**Application for Encroachment Agreement
267½ Glenholme Avenue (Amended)**

Date:	February 8, 2006
To:	Etobicoke York Community Council
From:	Curtis Sealock, Manager, Municipal Licensing and Standards
Wards:	Ward 17 - Davenport
Reference Number:	ML&S Folder No. 06-139427 RAW

To report on an application for Encroachment Agreement submitted by the owner to maintain an existing chain link fence, part of which is sitting on a retaining wall, and the area enclosed therein (including an installed air conditioning unit and a hose reel) within the Earlsdale Avenue and Glenholme Avenue road allowance (for an area of approximately 101.14 square metres or 1,088.7 square feet), as well as part of an existing garage that is encroaching on the Earlsdale Avenue road allowance (for an area of approximately 3.74 square metres or 40.25 square feet) – see Attachments 2, 6 and 7.

Attachment 3 – Elevation Drawings

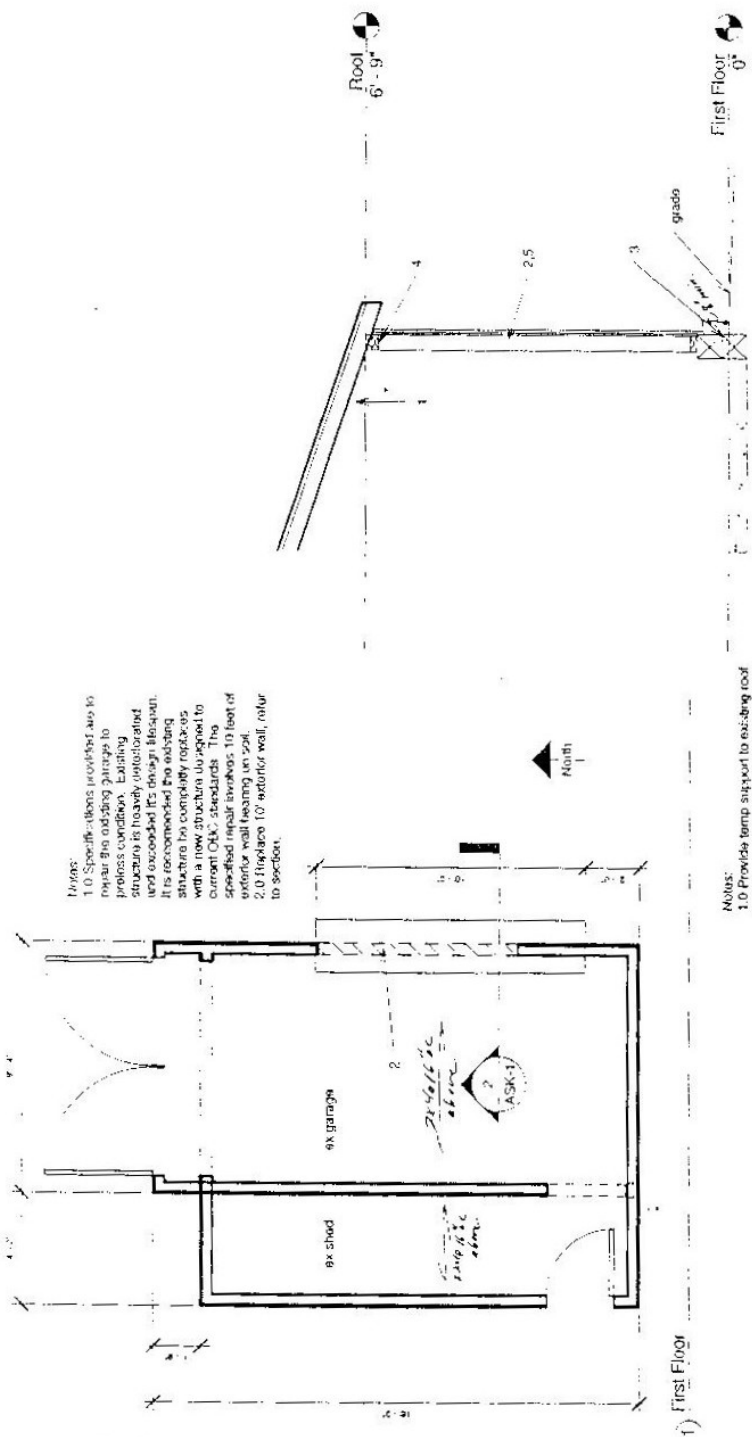
12. a handrail in compliance with Ontario Building Code to be installed at the front steps on Glenholme Avenue road allowance; and

Attachment 4: Garage Detail

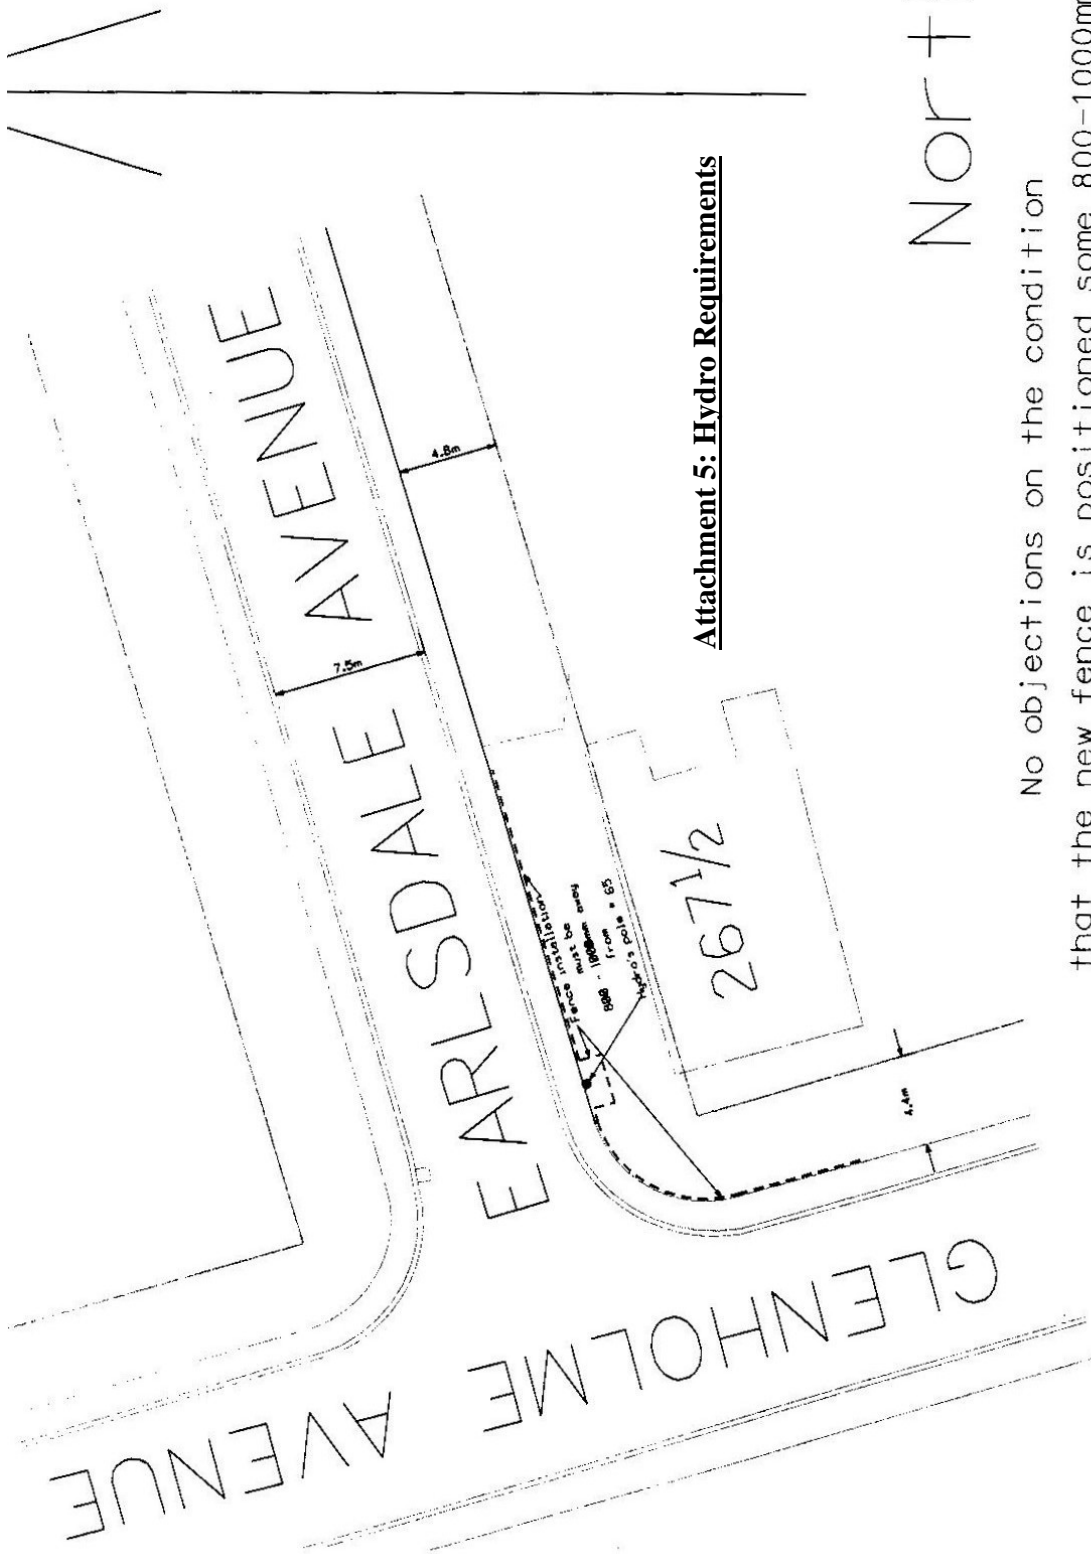
6. the owner to obtain a construction/streets occupation permit prior to the commencement of any construction;
7. the dilapidated garage to be repaired in accordance with Chapter 629 of the Toronto Municipal Code, Property Standards, and, should the repairs involve any structural alteration, drawings for a Building Permit are to be submitted to Toronto Building for approval – Attachments 4 and 6;

Notes:
 1.0 Specifications required are to repair the existing garage to process conditions. Existing structure is heavily deteriorated. It is recommended the existing structure be completely replaced with a new structure to meet current OBC standards. The specified repair involves 10 feet of exterior wall bearing on soil.
 2.0 Replace 10' exterior wall, refer to section.

Notes:
 1.0 Provide ramp support to existing roof frame.
 2.0 Remove 10' of existing 2x4 wall on existing soil, abut to existing floor slab.
 3.0 Install 10' two ply 17' 6x6 timber sill on existing soil, abut to existing floor slab.
 4.0 Insert 2nd ply 2x4 top plate below existing single plate.
 5.0 Repair 2x4 wall @ 16" oc, 1/2" plywood sheathing. Finish with asphalt shingles.
